EVALUATION OF MAINTAINABILITY ENHANCEMENT FOR TCP/TSP REVISION 6.0 UPDATE .20

> Norman F. Schneidewind February 1982

Final Report: 1 Jan 80 to 1 Jan 82

The Trident Command and Control Systems Maintenance Agency Newport, Rhode Island

FIGURE 4.2 CT Hierarchical Structure (1 of 5)

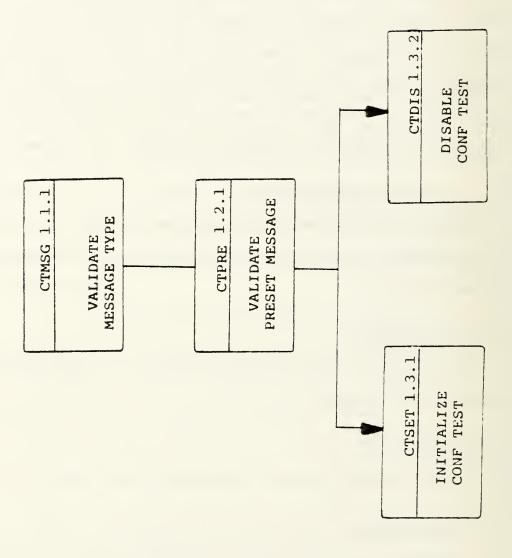
- 2. A consistent hierarchical structure box numbering system should be utilized which would indicate at a glance two important pieces of information: the function (e.g., "Periodic Entry") to which the routine belongs, and the level of the routine within the function. This scheme is shown on the accompanying hierarchical structure diagrams, which were reproduced from Volume 2 (pages 4-4 to 4-8). The left digit is function number, the middle digit is level number and the right digit is routine number for a given level and function. Level numbers start at "1" and increase from top to bottom; routine numbers start at "1" and increase from left to right. These numbers should be referenced to the pertinent flowcharts, as shown on the accompanying diagrams (pages 4-9 to 4-12 of Volume 2). As a means of tying together hierarchical structure diagrams, flowcharts and listings, the identification numbers could be appended to the listings as shown on the reproduced CMS-2 Assembler listing (page 6 of listing), which is attached. Two columns are utilized: one is the "At" column corresponding to lines with labels; the other is the "To" column corresponding to lines with transfer of control. Perhaps these identifiers could be punched and printed in formatted columns as part of the "Comments" field. A further help would be to sort source statements by the "At" column and to indent based on the middle digit. This would provided a structured listing of an entire function in contiquous locations.

FIGURE 4.2 CT Hierarchical Structure (4 of 5) Page 4-7

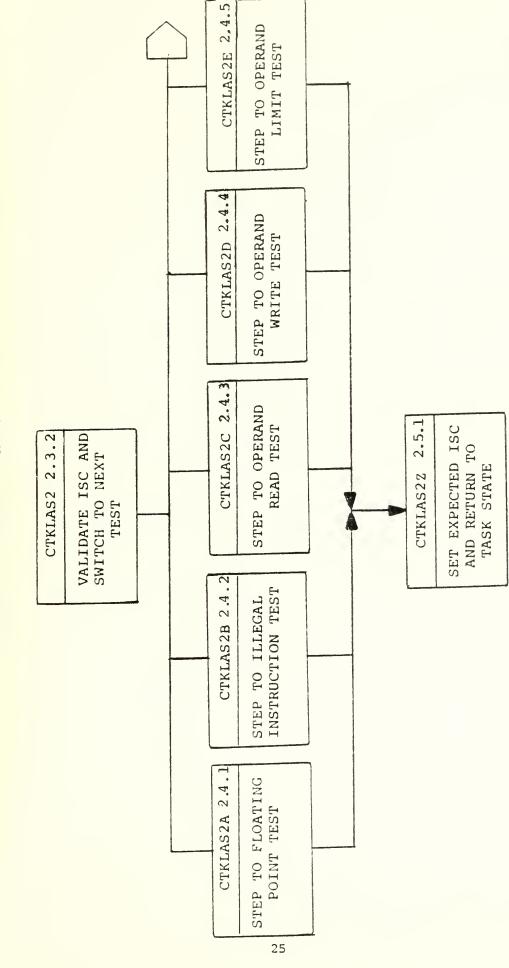
- b. Pages 4-7 and 4-8, figure 4.2, show CTKLAS2 as having access to CTKLASY. The listing indicates that this actually occurs via CTKLIPI (lines 314 and 342), which is not listed as a routine in figure 4.1, page 4-2 of volume 2. CTKLIPI also has a path to CTARITH via CTKL2XIT at line 349. Page 4-8 also shows no path between CTKAS2I and CTKLASY*. However, the listing shows this path to exist. This condition was verified by consulting the CMS-2 Assembler List Cross Reference Table. One of these references to CTKLASY occurs from the same routine.

- Pages 4-7 and 4-8 show no path between CTKLAS2 and CTKLAS2Z. However, line 335 on the listing shows that this label is contained within routine CTKLAS2.

FIGURE 4.3 CT Flowcharts (1 of 25)
Page 4-9

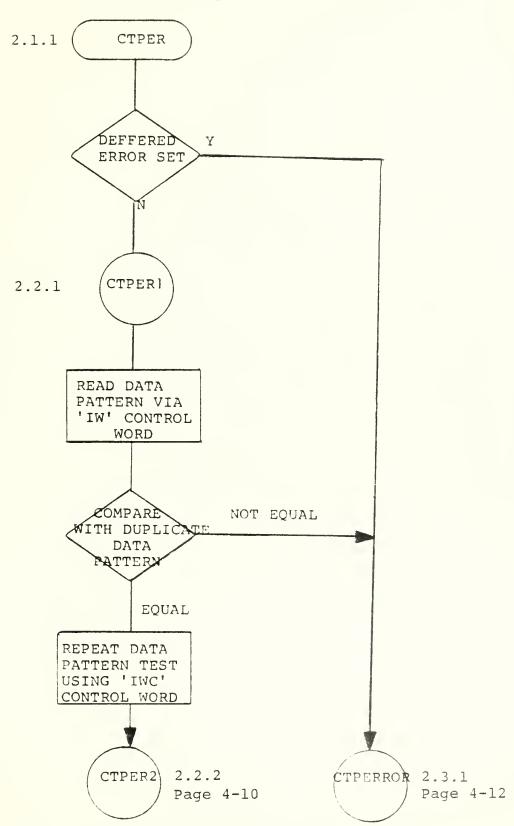
- 1. The entry to a flowchart page should be annotated with the flow-chart page numbers which are associated with the source(s) of the transfer of control and the exit(s) from a flowchart page should indicate the page number(s) which are associated with the destination(s) of the transfer of control. This is shown on the attached pages 4-9 to 4-12 of Volume 2.

- 2. There is no loop back to CTPER1 on page 4-9 of the flowcharts, as indicated by the JBNZ instruction at line 223 on page 6 of the listing. Instead the box at the bottom of page 4-9 reads: "Repeat Data Pattern Test Using 'IWC' Control Word." Similarly there is no loop back to CTPER2 on page 4-10 nor loop back to CTPER3 on page 4-11, as shown by line 230 and 238, respectively, on the listing. This method of presentation seems to mask an important characteristic of the program logic.

FIGURE 4.3 CT Flowcharts (3of 25) Page 4-11

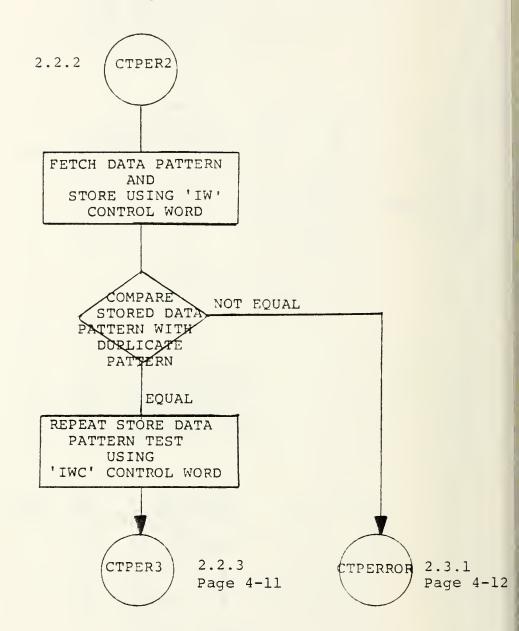
- 3. There seem to be discrepancies between flowcharts and listings. For example, the second box from the bottom of page 4-11 figure 4.3 refers to IWC. Page 6, lines 243 and 244 refer to ICW. The box in the flowchart also refers to "Set Up Class IV," while line 243 on the listing refers to Class II.

REVISED FIGURE 4.2 CT HIERARCHICAL STRUCTURE (2 OF 5) REVISED Page 4-5

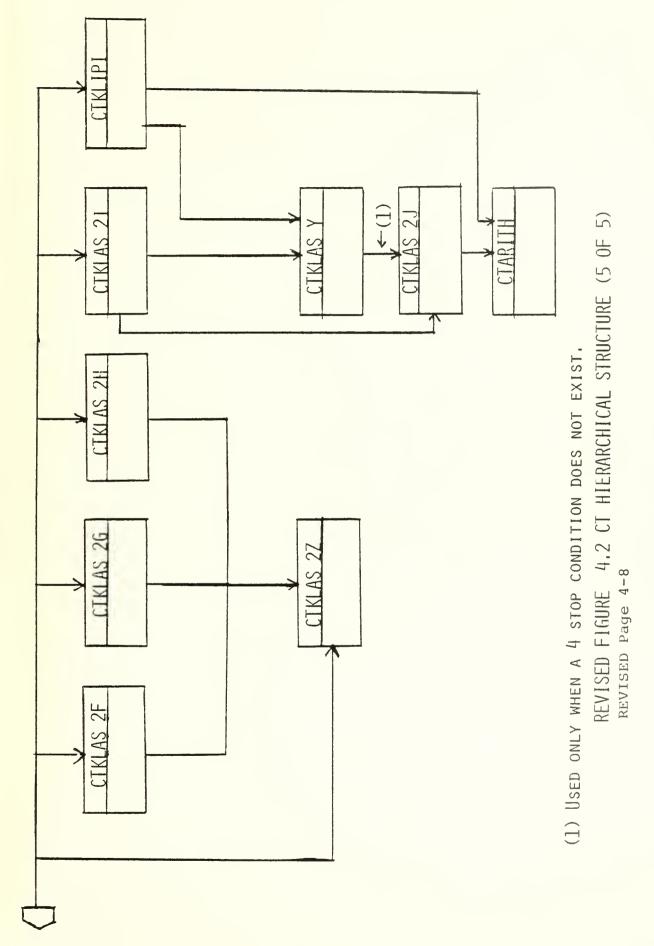
- a. With respect to page 4-5, figure 4.2, CTPER is shown superior to all other routines on this chart, yet an analysis of the listing reveals that CTPER only happens to be the first label in this series of code and its only paths to other labels are to CTPERl and CTPERROR. The latter reference brings to light another discrepancy. CTPER does have a conditional branch to CTPERROR in the listing (line 219), but according to figure 4.2, there is no path between these routines. With respect to figure 4.2, the listings indicate the following access paths among routines:
 - CTPER accesses CTPER1 and CTPERROR.
 - CTPERL accesses CTPER2 and CTPERROR.
 - CTPER2 accesses CTPER3 and CTPERROR.
 - CTPER3 accesses CTRTN and CTPERROR.

Thus, a more accurate picture of this logic is shown in the diagram labeled "Revised Figure 4.2 CT Hierarchical Structure (2 of 5)." It should be noted that in this diagram the horizontal lines indicate paths between adjacent code segments that are in the same module and vertical lines indicate paths involving transfer of control. Also, the arrows, from left to right and from top to bottom, indicate the general direction of control flow. In large measure the "routines" which have been shown as hierarchical structures boxes in Volume 2 are simply labels in a segment of code. This has been pointed out in Volume 2 on page 4-3. The difficulty in constructing the hierarchical structure from program listings is that by definition, the diagrams are supposed to indicate hierarchy, i.e., superior-subordinate relationships, and programs designed using a top-down approach. Since the
